ACTGPT-24a

Address	McGilvray Close, Gordon
Device	Custom GPT
Site Details	Access way off McGilvray Close
Estimated catchment area	-
Device Status at Nov 2014	Operational, device 15% full
Device comments and recommendations	<p>This device seems appropriately sized for the catchment, but its size is unknown. Regardless it would be improved with increased rack size and design</p> <p>Extra set of racks could be installed or one set of racks running along the northern edge of the sediment basin to create a high flow bypass to help avoid already trapped pollution being washed away.</p> <p>Grass cutting around the area should be done with a catcher as grass is being washed down into the rack and this breaks down and sends the GPT anaerobic</p>
Rectification works required	<p>Install new higher racks and high flow bypass</p> <p>Repair erosion damage upstream</p>
Existing maintenance	TBC
Maintenance expectations with rectifications	Quarterly

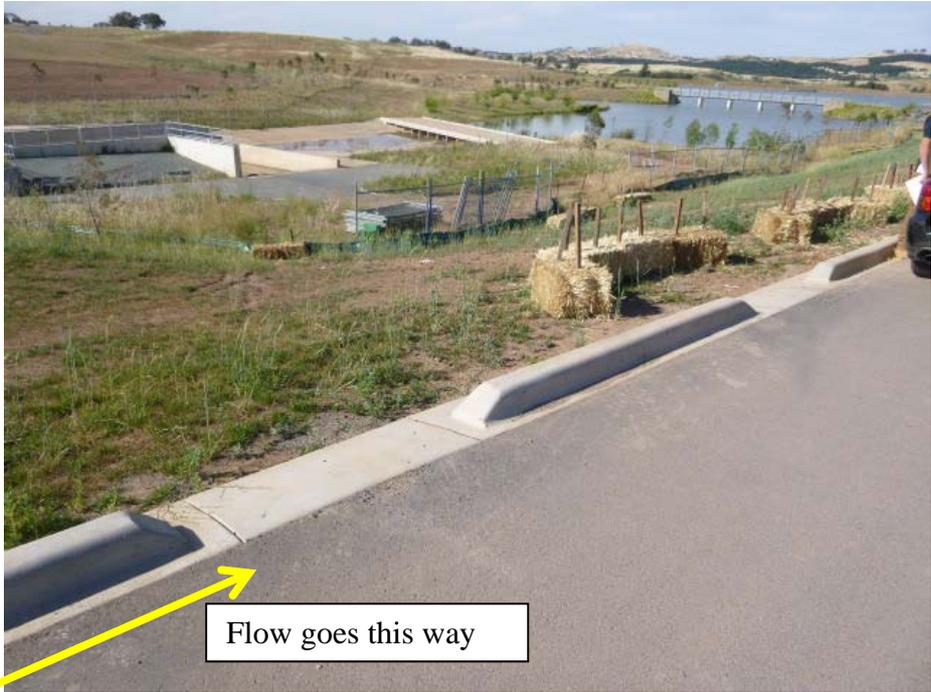
the inlet forcing the Stormwater to bypass treatment and go straight to the lakes. The internals of the CDS unit have not been fixed in place correctly.

The kerb is designed to allow water to run off in a diffuse way, yet discourage drivers from taking a vehicle down the embankment. However, the hay bale placement is poor.

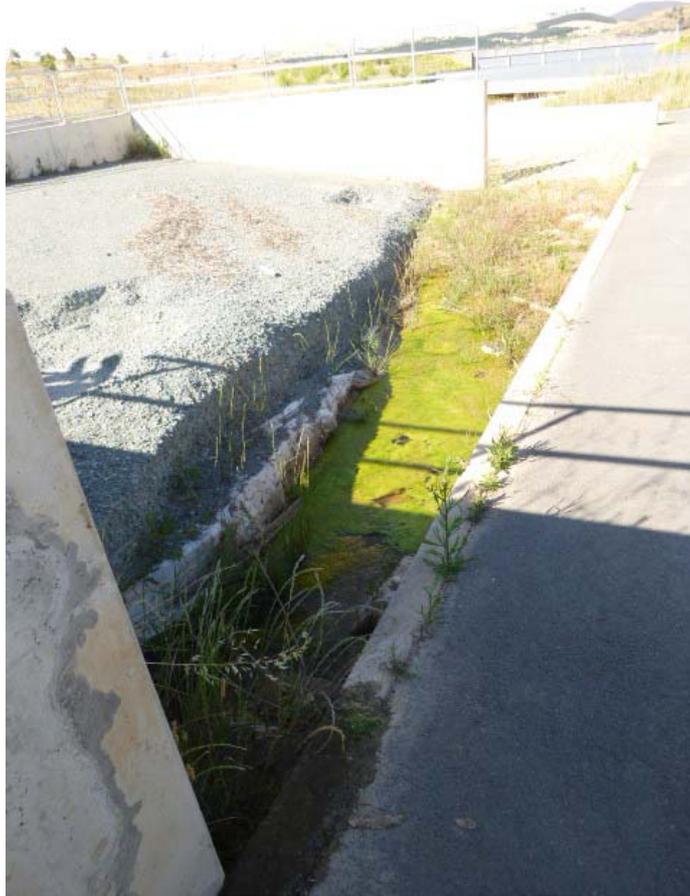
Drying pad at site, the nearest edge is being eroded away

Massive erosion due to a design oversight. This should be fixed as soon as possible to prevent any further erosion.

Trash rack and sediment basin

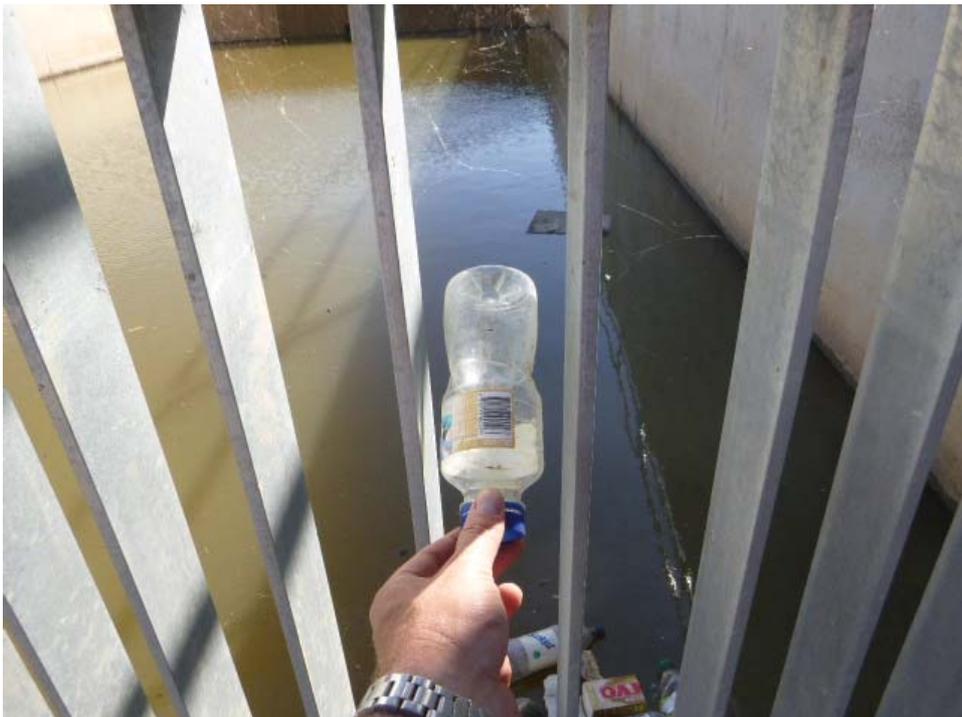
The low flow bypass is silted up and the silt fencing on the site fencing is directing water around the GPT

The wire fence beside the GPT is collecting pollution when the device bypasses

Aperture of the bars is too wide

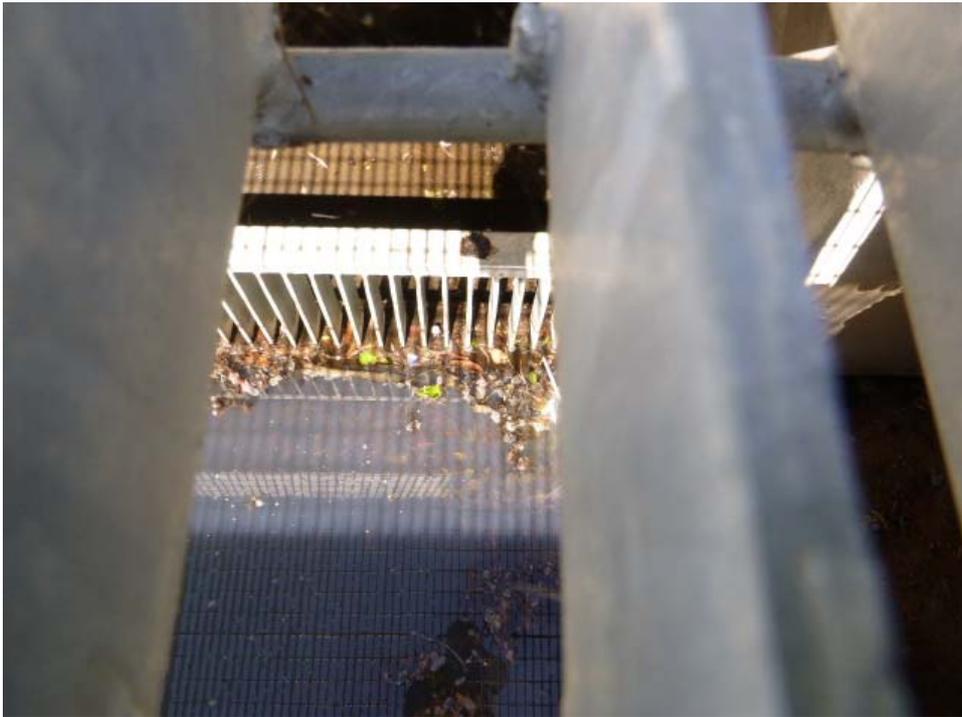
Site around the chamber has plenty of room.

Sediment build-up inside chamber.

Floatables and organics collect in corners of the lake. This is determined by the prevailing wind, but a walkway around the edge or a floating boom would aid collection.
